Addendum 1 for RFB927920-01

Project Name: WRC Decentralization Phase 2 & Fire Alarm & Myers Hall Sprinkler
DAS RFB #: 927920-01
DAS Project #: 9279.20-21 & 9294.00
Date: 2/16/2023

A4 FIRE PUMP PLAN
1/2" = 1'-0" 0' 3"

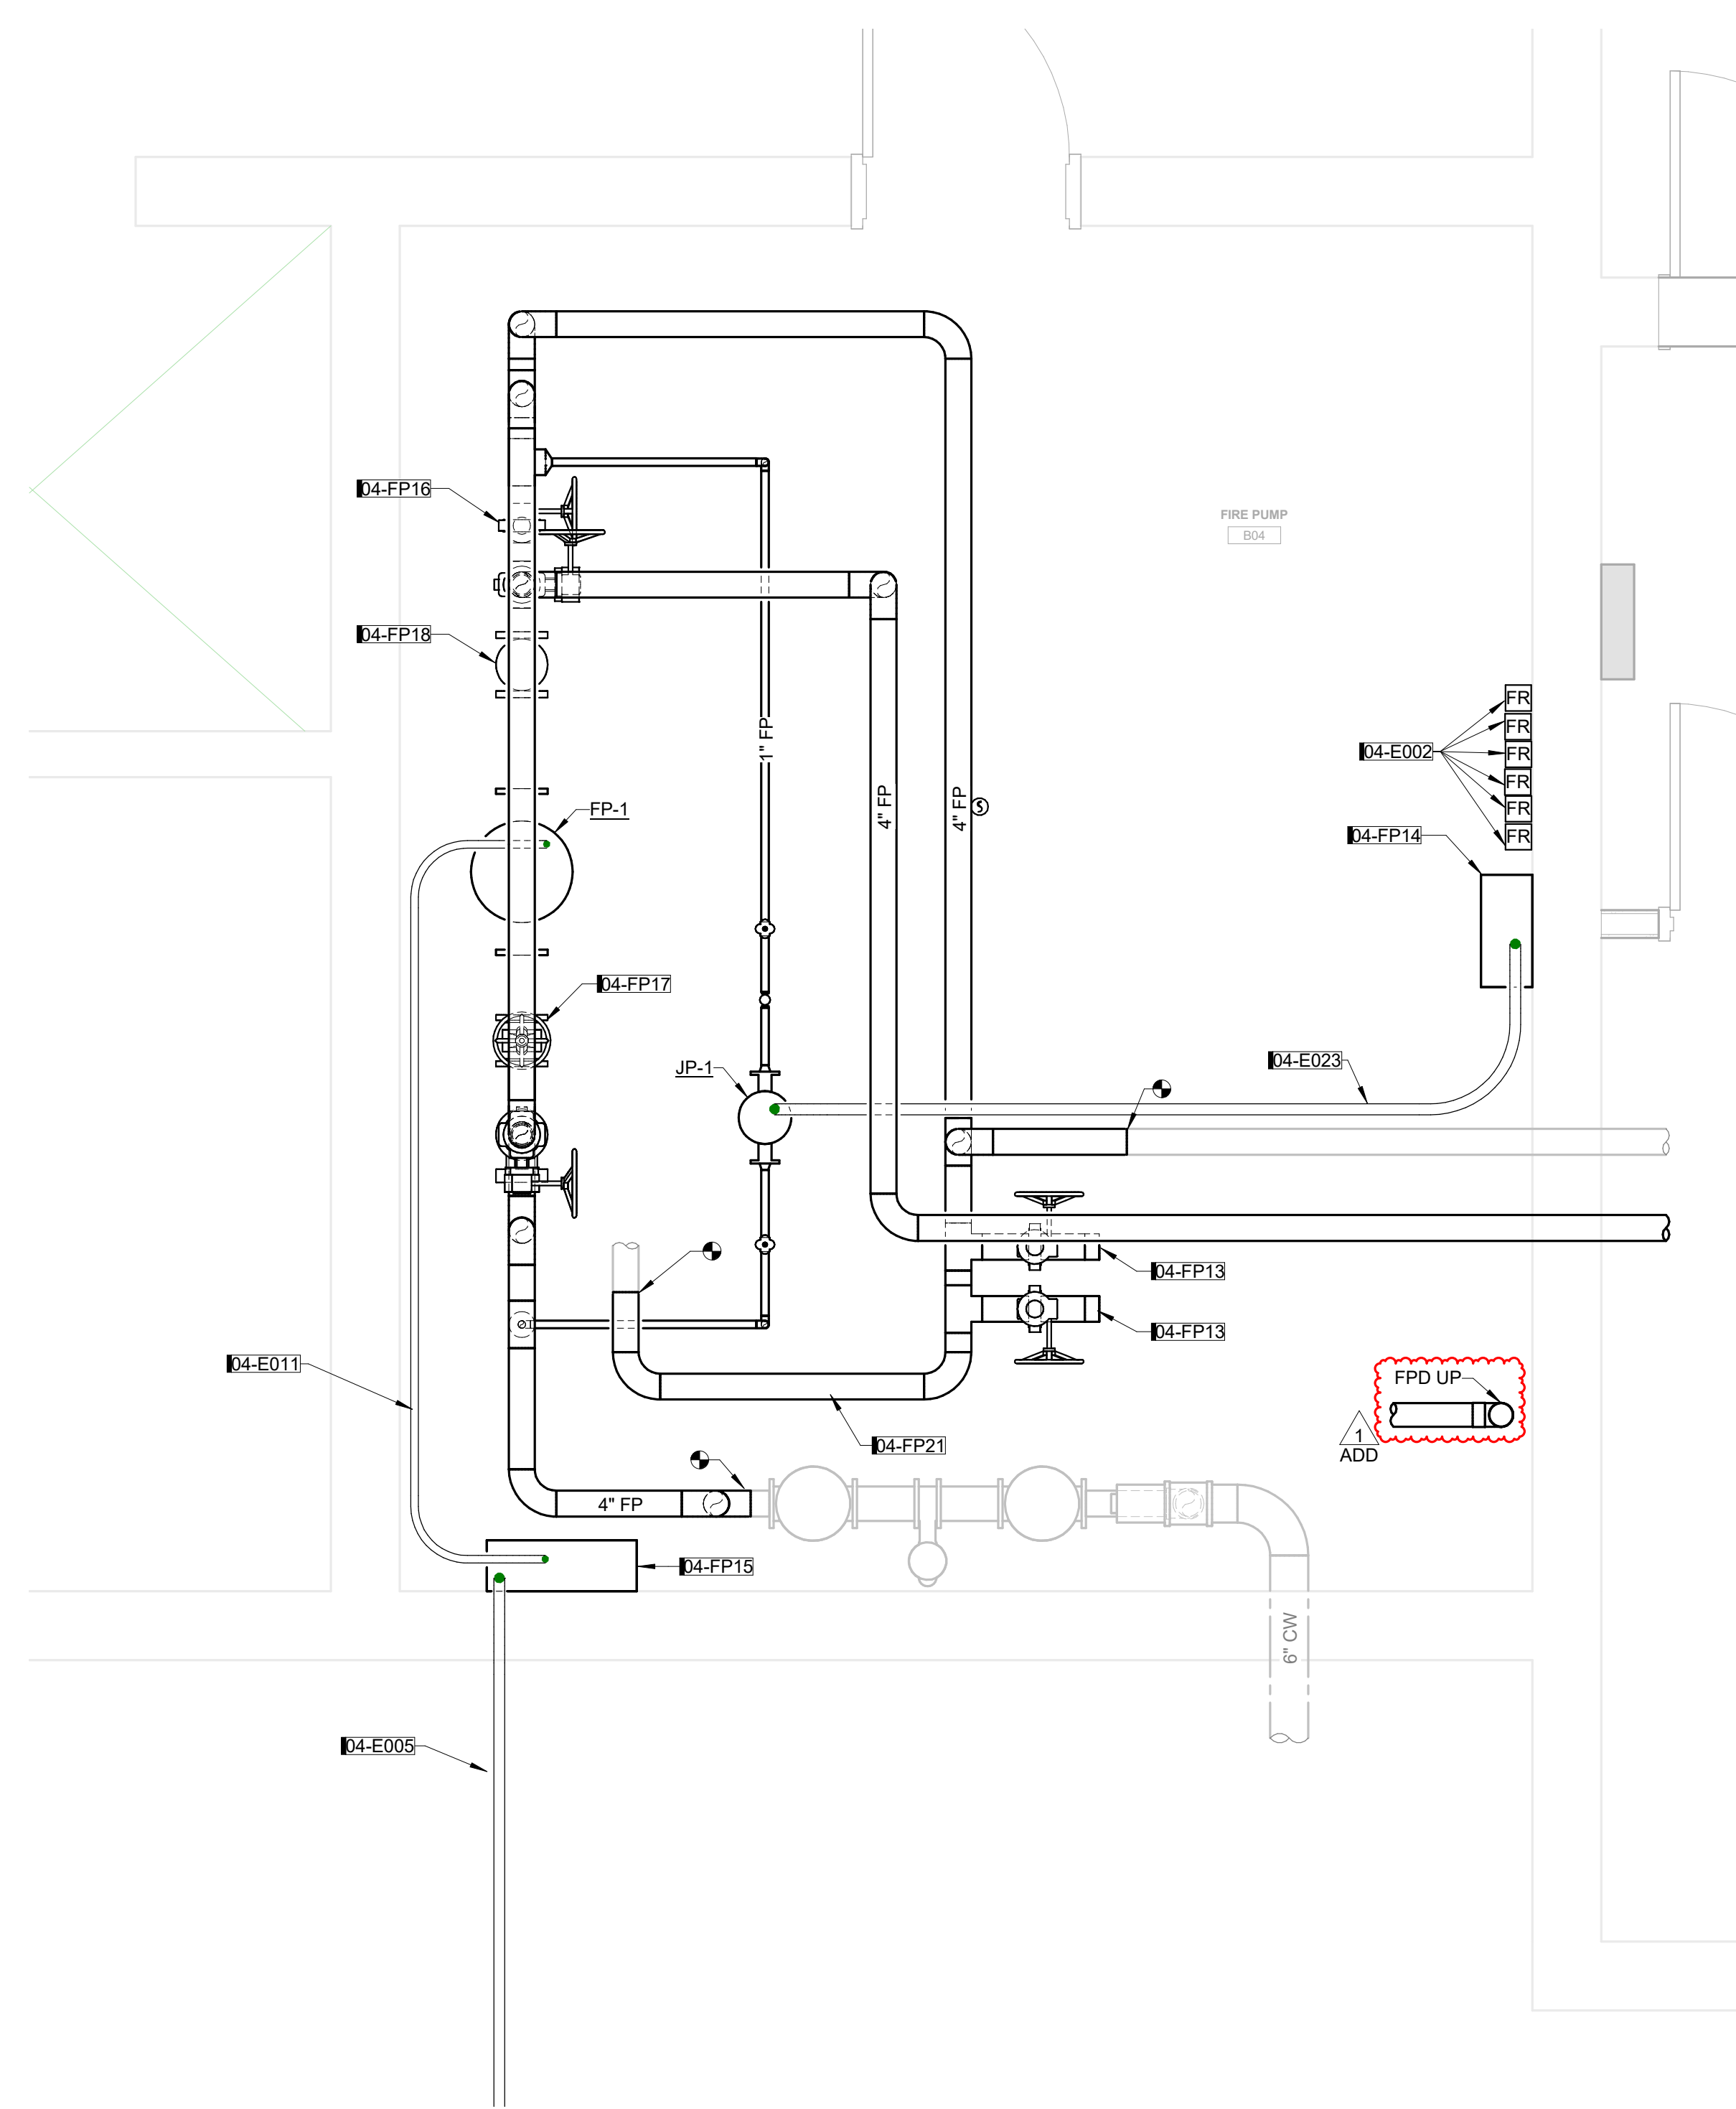
- **ADD** dry sprinkler riser to FIRE PUMP PLAN.
- **04-MD100 – BASEMENT MECHANICAL PIPING DEMOLITION PLAN**
 - **ADD** keynote 04-MD5 regarding demolition of steam piping. See attached sheet for further information.

E6 SPRINKLER RISER DIAGRAM
NOT TO SCALE

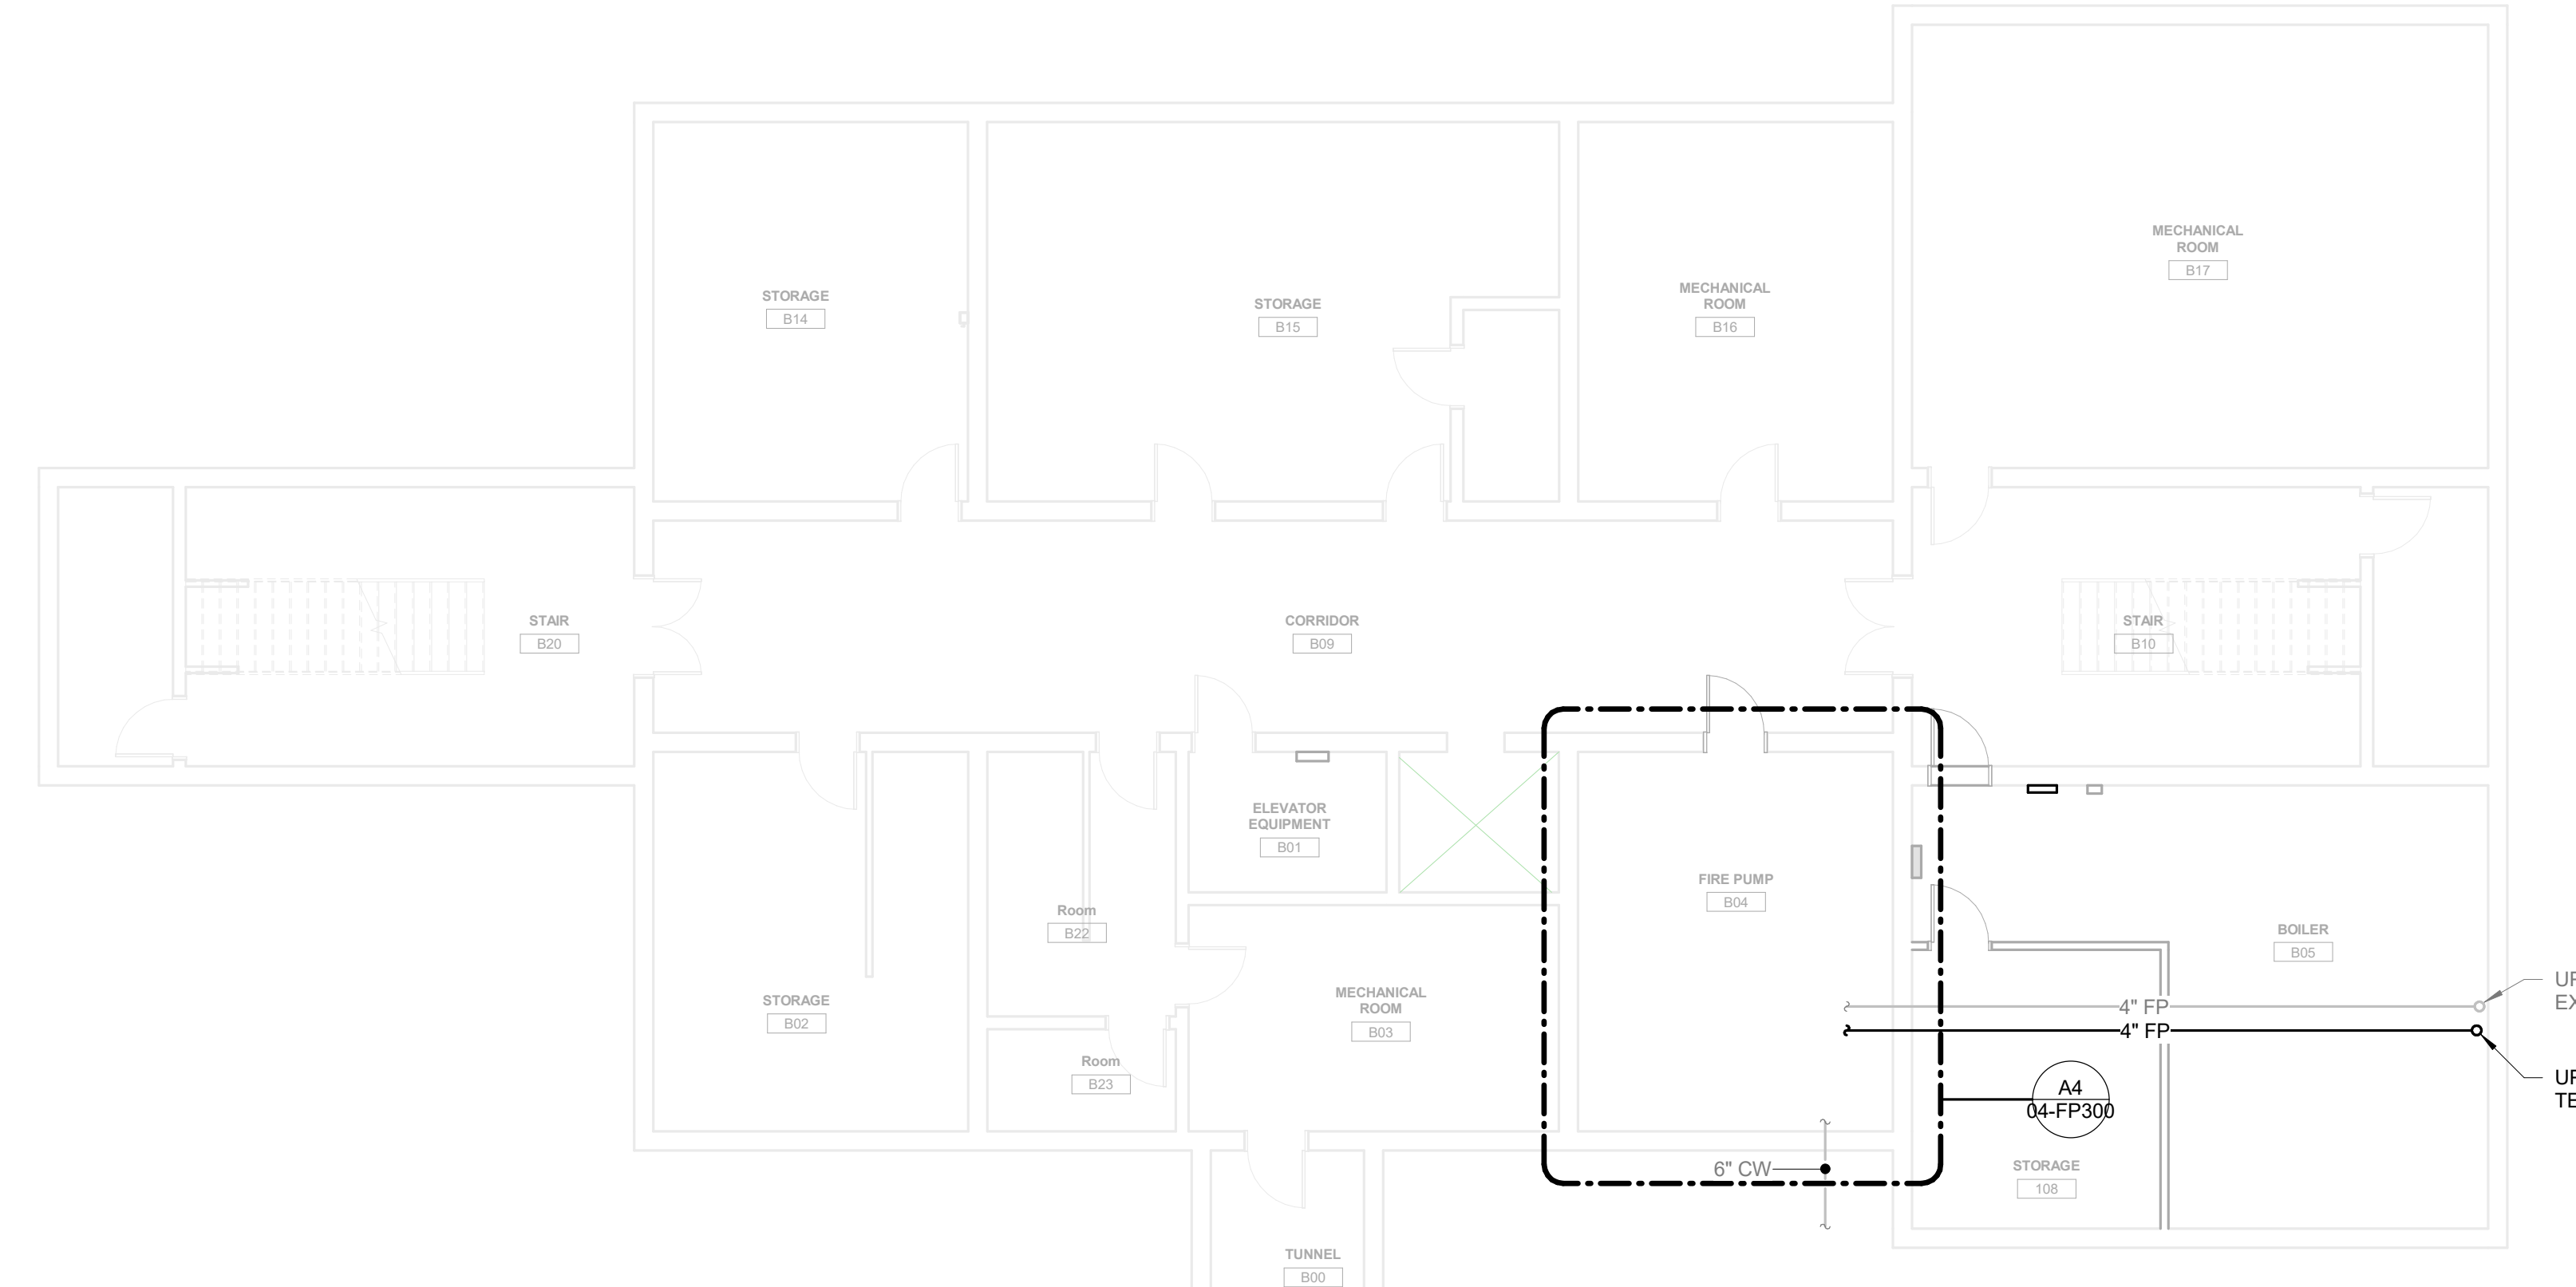
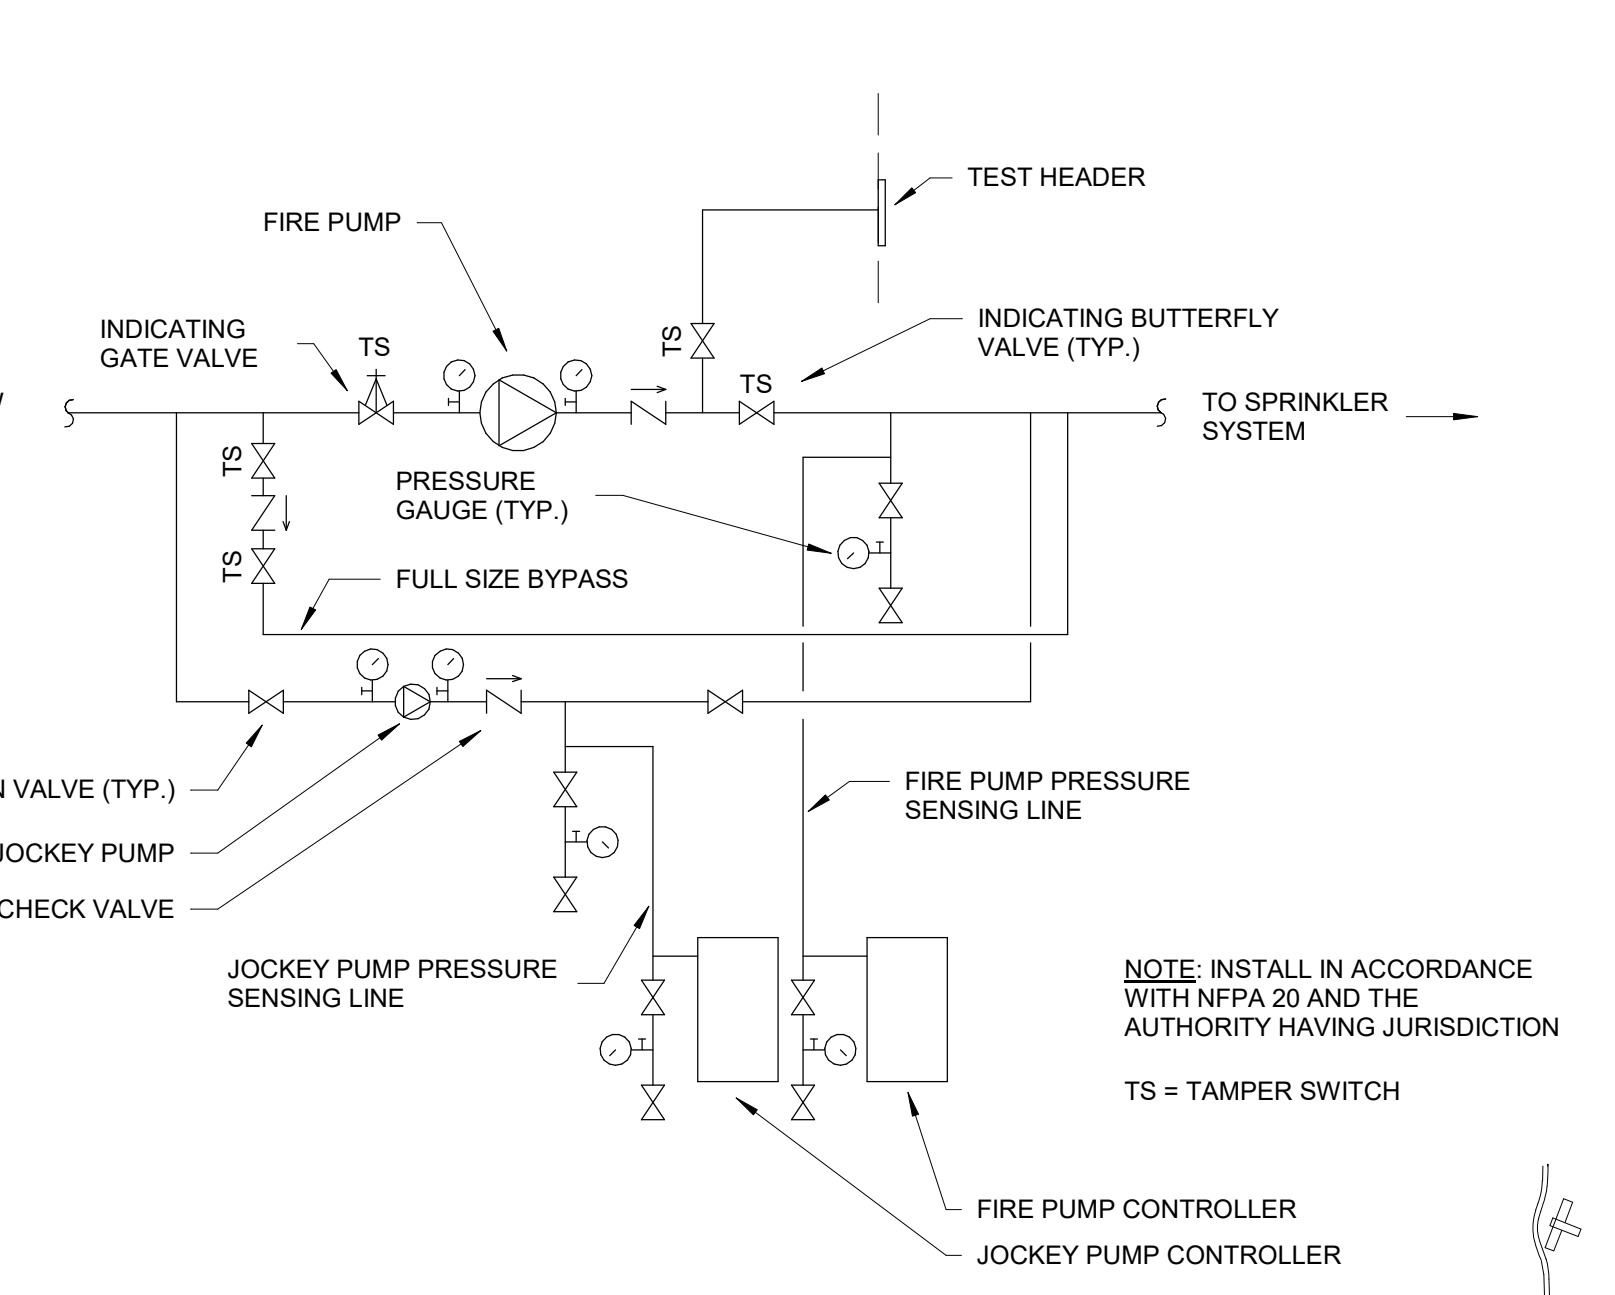
- **04-FP103 - ATTIC FIRE PROTECTION PLAN**
 - **ADD** sheet to project.
- **04-FP300 - FIRE PUMP PLANS, DETAILS & SCHEDULES**
 - **REVISE** SPRINKLER RISER DIAGRAM to show dry sprinkler riser.
